**OHIO TURNPIKE AND
INFRASTRUCTURE COMMISSION**

ADDENDUM NO. 2
ISSUED JANUARY 16, 2020

PROJECT NO. 39-20-02 (PART A)
MAINLINE PAVEMENT RECONSTRUCTION
MILEPOST 46.50 TO MILEPOST 50.92
FULTON & LUCAS COUNTIES, OHIO
ISSUED DECEMBER 30, 2019

PROJECT NO. 39-20-02 (PART B)
TOLL PLAZA 49 SITE CONSTRUCTION
MILEPOST 48.8 TO MILEPOST 49.1
LUCAS COUNTY, OHIO
ISSUED DECEMBER 30, 2019

MAINTENANCE OF TRAFFIC PLAN
PRE-PHASE 2
STA. 19+50 TO STA. 32+50

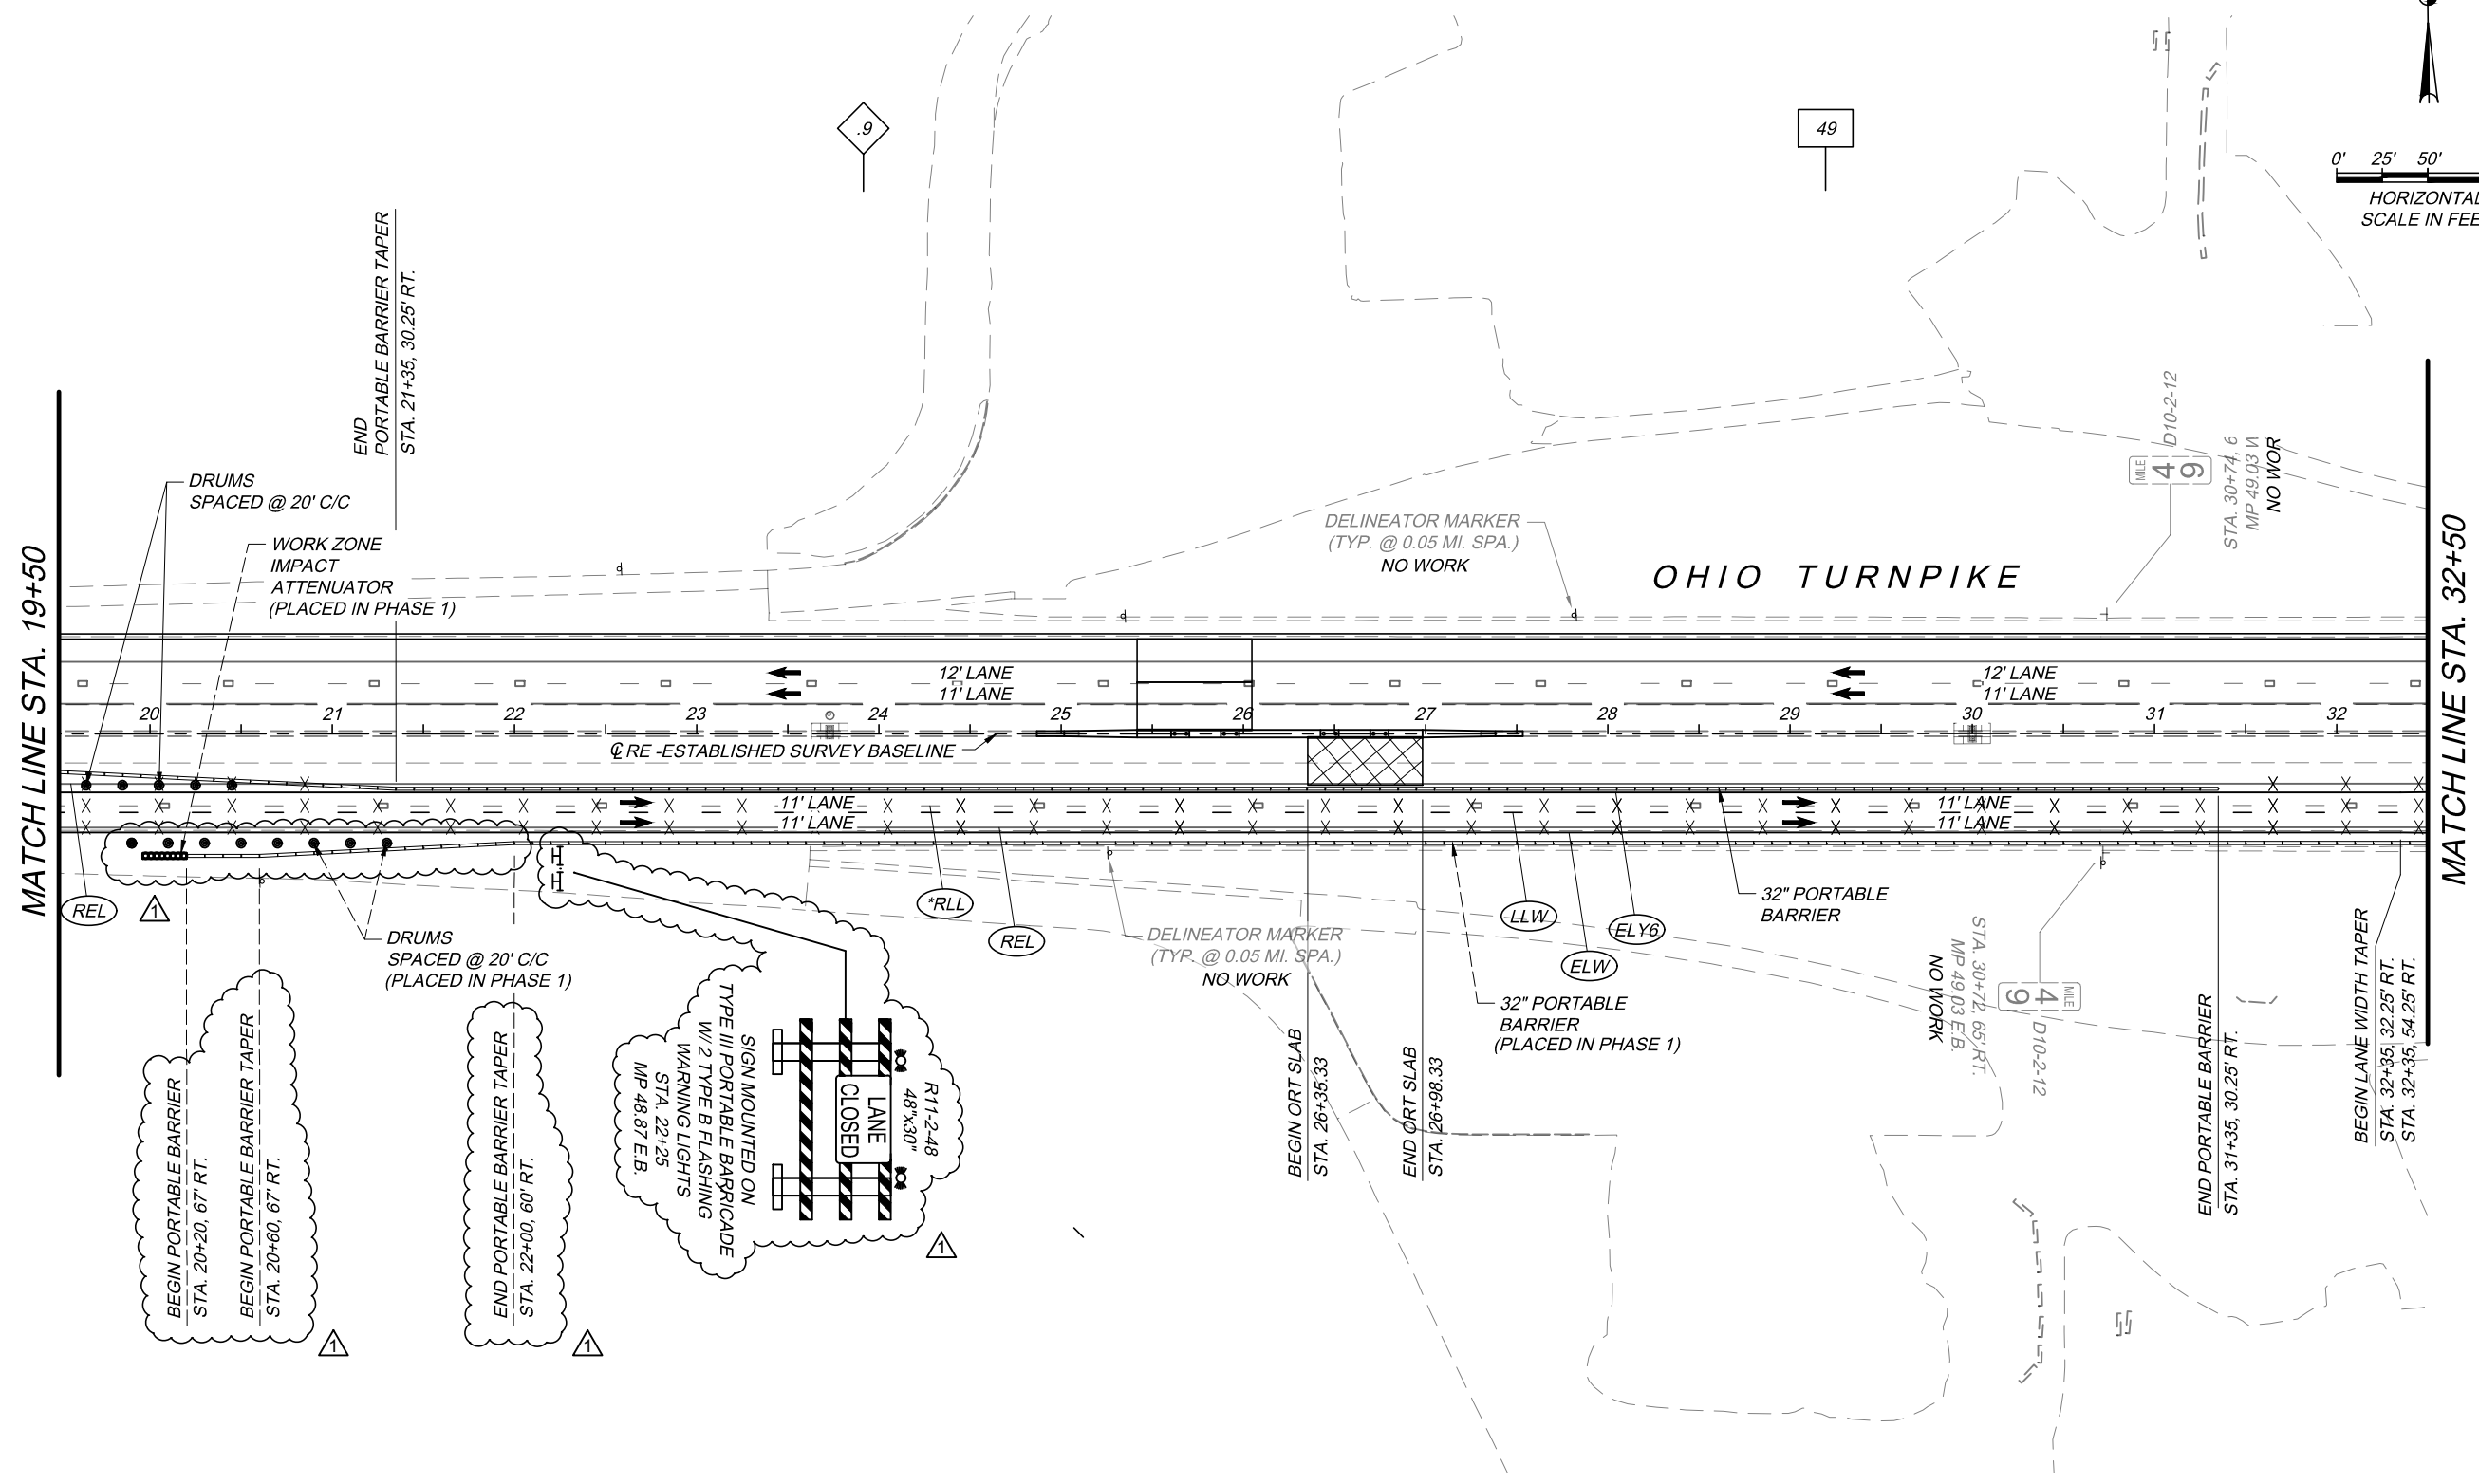
Q#31 Part B, sheet 13 shows EB toll plaza pavement work to be performed being built up through the SP302 prior to September 30, 2020. Assuming that these limits are from 118+69 through 133+70 (Part B- sheets 19 and 20), then there is a conflict with the Part A maintenance of traffic plan sheet 78 which shows the portable barrier in phase 1 starting at 21+70. Should this PCB taper in phase 1 be extended to the west so that pavement construction on the EB plaza can begin accordingly? Please review the part A MOT plan as it relates to EB part B construction and revise the MOT sheets as required in an addendum.

A#31 This Addendum No. 2 revises Part A Maintenance of Traffic Sub Summary Sheet No. 42 and Maintenance of Traffic Plan Sheet Nos. 78, 109 and 126 of 505 to extend the portable barrier to STA 20+20, 67' RT to avoid conflict with the Contract 58-20-01 staging areas to be constructed in this Contract prior to September 1, 2020 as shown on Part B Sheet 9 of 59. A note was modified on the Contract Coordination Plans, Sheet 13 of 59 to further describe what portion of SP 302 is to be performed on the Eastbound Toll Plaza prior to the September 1, 2020.

PROJECT 39-20-02A
PLAN AND PROFILE
STA. 35+00 TO STA. 47+00

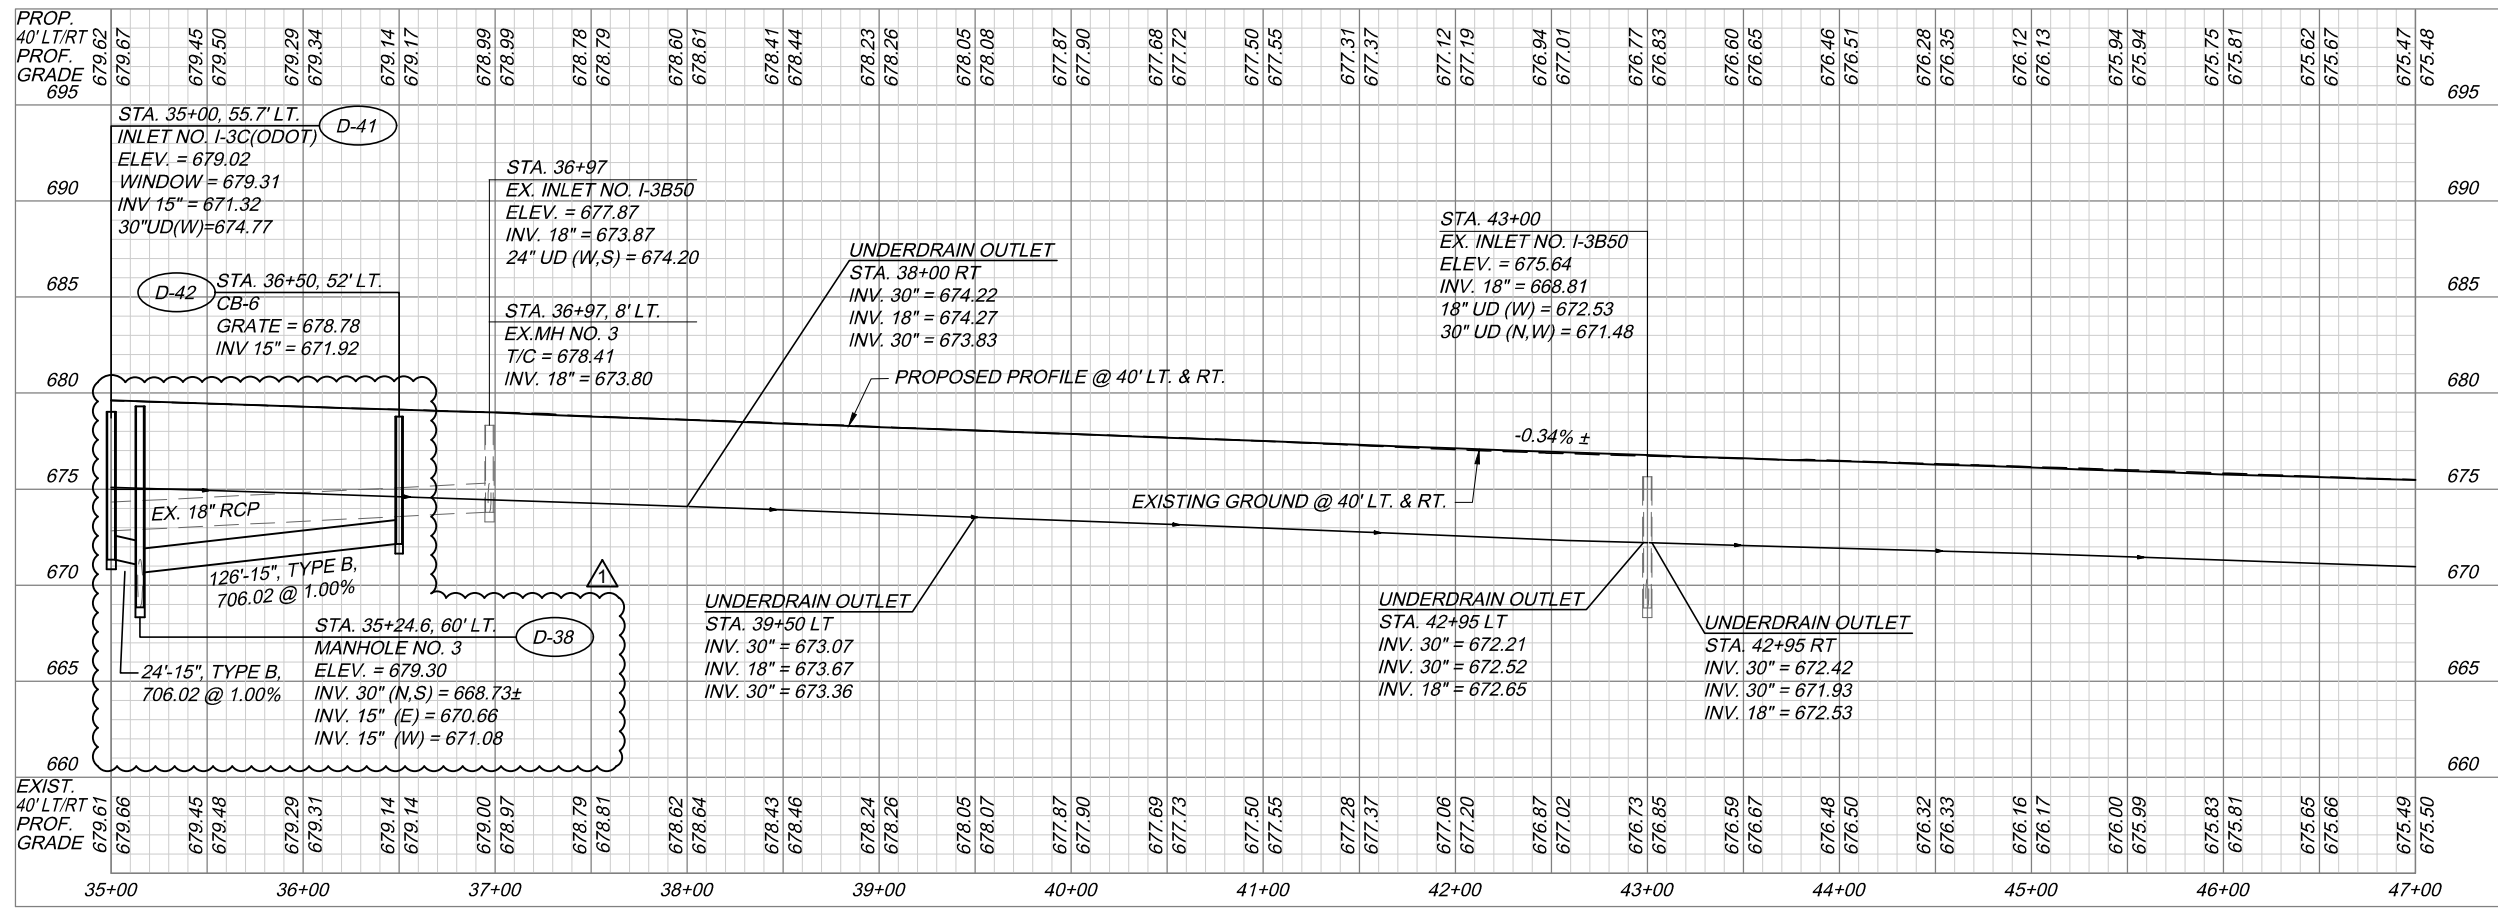
Q#11 Bid item 102- there are two runs on the WB side (sheet 208, runs D-41 and D-42) which are to be core-drill connected to an existing 30" concrete pipe. Given the size of cores needed to accommodate the 15" RCP connections, these will most likely damage or destroy the existing 30" pipe. Please consider adding a new manhole at this junction of the new and existing pipes.

A#11 This Addendum No. 2 revises General Summary Sheet Nos. 169 and 171 of 505, Drainage Sub Summary Sheet Nos. 177 and 178 of 505, Plan and Profile Sheet No. 208 of 505 and Cross Section Sheet Nos. 320 and 321 of 505, and revises Reference Nos. 7, 105 and 114 on the Bid Schedule of Items and the Estimated Quantities Worksheet. The quantity for Pipe Removed, Over 24" was revised on Plan Sheet Nos. 169, 177, and 178 of 505. The quantities for 30" Conduit, Type B, 706.02 and Manhole, No. 3 were revised on Plan Sheet Nos. 171, 177, and 178 of 505. Plan Sheet Nos. 208, 320 and 321 of 505 added a manhole, removed and added 30" Conduit, Type B and eliminated the core drilled holes in the existing 30" storm sewer.

STA. 26+47.33, CL.
 STA. 26+47.33, 68'-10" RT.
 MP 48.95, I-80/90 E.B.
 OVERHEAD SIGN SUPPORT
 TC-7.65, DESIGN 8

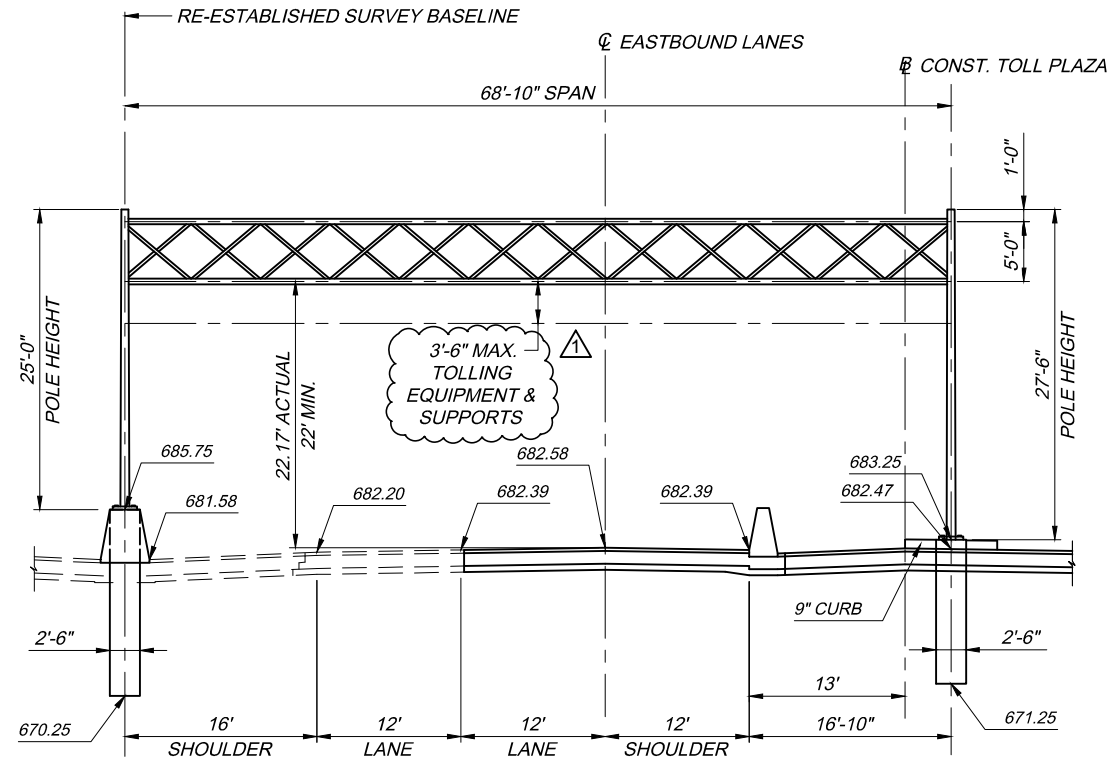
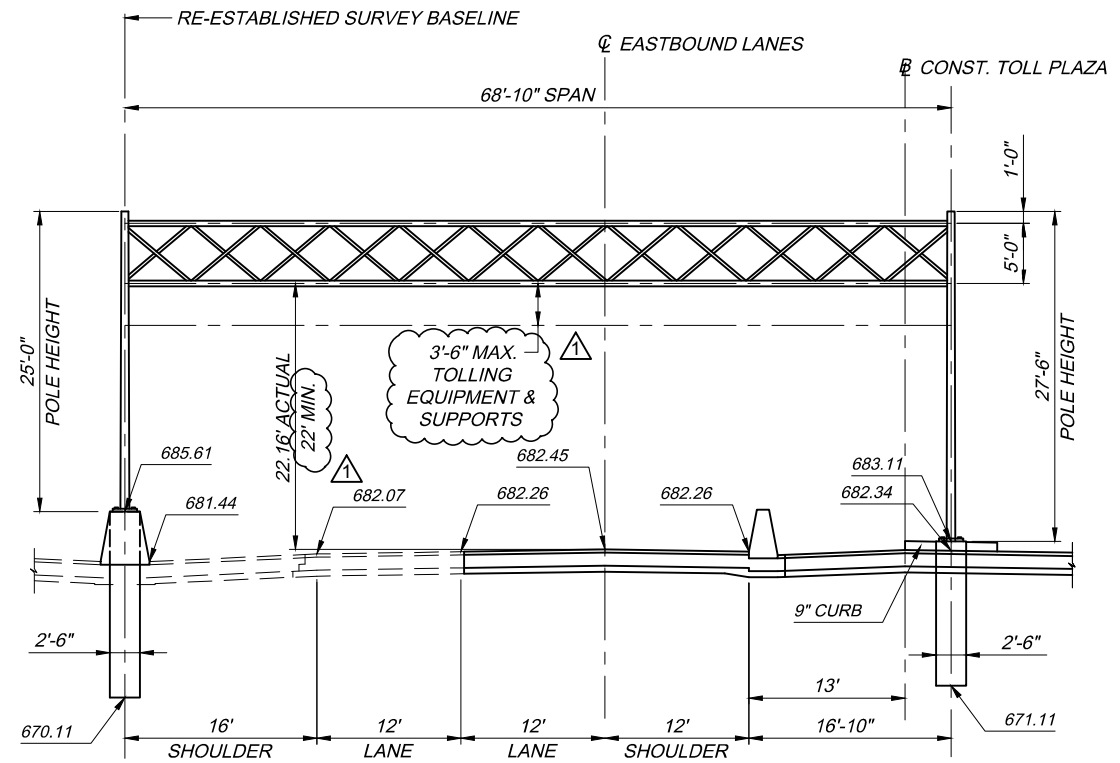
Q#41 On plan sheet 472/505, MP 48.95 diagram states 22' Min from top of pavement to bottom of overhead sign support, but the MP 48.96 diagram on same sheet states 17' Min, which is also noted as 17' Min on plan sheet 474/505. Which is correct?

A#41 This Addendum No. 2 revises Plan Sheets 472 and 474 of 505 to clarify 22' Minimum is required.

TOLL PLAZA APPROACH & DEPARTURE-NORMAL SECTION
 EASTBOUND SHOWN. WESTBOUND SYMMETRICAL ABOUT RE-ESTABLISHED SURVEY BASELINE

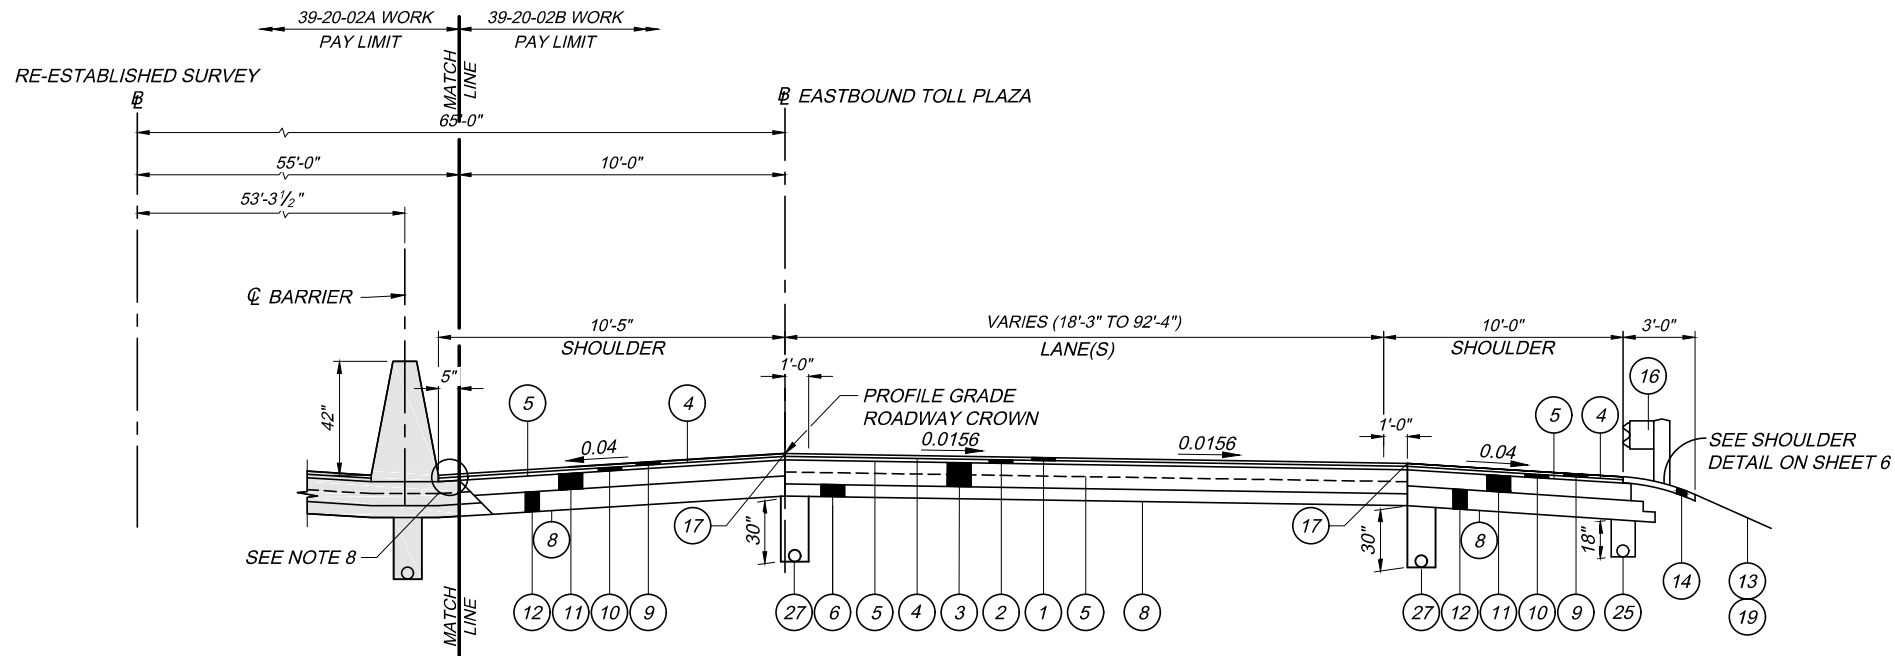
Q#37 On Plan Sheet 3 of 59 in Part B, the Item Legend calls out items #31 thru #36 for various thicknesses of asphalt paving and pavement planing. These items do not appear in any of the provided typical. What are they for?

A#37 This Addendum No. 2 revises Typical Section Legend Nos. 31 thru 36 on Toll Plaza Sheet No. 3 of 59 to read "Not Used".
